Access Compliance Report

Public Rights-of-Way

(Pedestrian Signals)

Intersection ID: N/A	Main Street:	Cross Street: N/A	Location: N/A
ADA ID: 50F50FFDA0A9	Signal Type: Two Push Buttons-Non APS	Overall Compliance: No	Severity Score: BTN 1:N/A BTN 2: N/A No BTN: N/A
Codes/Mitigation Info/Possible Solution		Field Measurements/Component Compliance

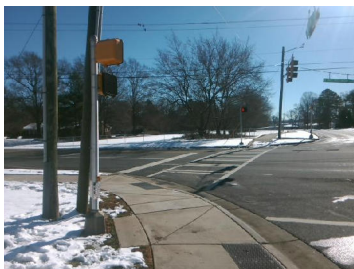
Compliance	Description	Data	Compliance	Description	Data
	Button Count	Button2	N/A	Distant to Additional Button (in)	N/A
	Additional Button Present?	No		Additional Button ID	N/A
N/A	Signal Buttons Required?	N/A	N/A	Additional Ped Posts Required	N/A
	How Many Ped Street Xings?	N/A		Located In An Island/Median?	N/A
N/A	B 1 Sign Present?	Yes	N/A	B 2 Sign Present?	Yes
Yes	B 1 Sign Purpose?	Yes	Yes	B 2 Sign Purpose?	Yes
Yes	B 1 Sign Lettering & Contrast?	Yes	Yes	B 2 Sign Lettering & Contrast?	Yes
Yes	B 1 Parallel To XWalk?	Yes	Yes	B 2 Parallel To XWalk?	Yes
Yes	B 1 PAR to Button?	Yes	Yes	B 2 PAR to Button?	Yes
Yes	B 1 PAR to XWalk?	Yes	Yes	B 2 PAR to XWalk?	Yes
Yes	B 1 Clear Floor Space?	Yes	Yes	B 2 Clear Floor Space?	Yes
N/A	B 1 FWD Approach?	Yes	N/A	B 2 FWD Approach?	Yes
N/A	B 1 FWD Approach Constrained?	Yes	N/A	B 2 FWD Approach Constrained?	Yes
No	B 1 FWD Approach Reach (in)	8.0	No	B 2 FWD Approach Reach (in)	8.0

Yes	B 1 FWD Approach Width (in)	56.0	Yes	B 2 FWD Approach Width (in)	56.0
N/A	B 1 FWD Approach Obstruction?	Yes	N/A	B 2 FWD Approach Obstruction?	Yes
N/A	B 1 FWD Approach Obstruction Dist (in)	3.0	N/A	B 2 FWD Approach ObstructionDist (in)	3.0
N/A	B 1 PARA Approach?	No	N/A	B 2 PARA Approach?	No
N/A	B 1 PARA Approach Constrained?	N/A	N/A	B 2 PARA Approach Constrained?	N/A
N/A	B 1 PARA Approach Reach (in)	N/A	N/A	B 2 PARA Approach Reach (in)	N/A
N/A	B 1 PARA Approach Width (in)	N/A	N/A	B 2 PARA Approach Width (in)	N/A
N/A	B 1 PARA Approach Obstruction?	Yes	N/A	B 2 PARA Approach Obstruction?	Yes
N/A	B 1 PARA Approach Obstruction Dist (in)	3.0	N/A	B 2 PARA Approach ObstructionDist (in)	3.0
Yes	B 1 Clear Floor Space Slope (%)	1.9	Yes	B 2 Clear Floor Space Slope (%)	1.9
Yes	B 1 Clear Floor Space XSlope (%)	1.0	Yes	B 2 Clear Floor Space XSlope (%)	1.0
N/A	B 1 PAR Slope (%)	N/A	N/A	B 2 PAR Slope (%)	N/A
Yes	B 1 Height (in)	36.5	Yes	B 2 Height (in)	36.5

N/A	B 1 Clear Xing Direction?	Yes	N/A	B 2 Clear Xing Direction?	Yes
	B 1 Crossing Direction	To SE		B 2 Crossing Direction	To SW
Yes	B 1 DistanceTo XWalk (in)	0.0	Yes	B 2 DistanceTo XWalk (in)	0.0
No	B 1 DistanceTo Curb (in)	97.0	No	B 2 DistanceTo Curb (in)	97.0
Yes	B 1 Diameter (in)	2.0	Yes	B 2 Diameter (in)	2.0

Possible Solutions: Replace Signal Push Button With APS Button on New Post. Remove & Relocate Sign.
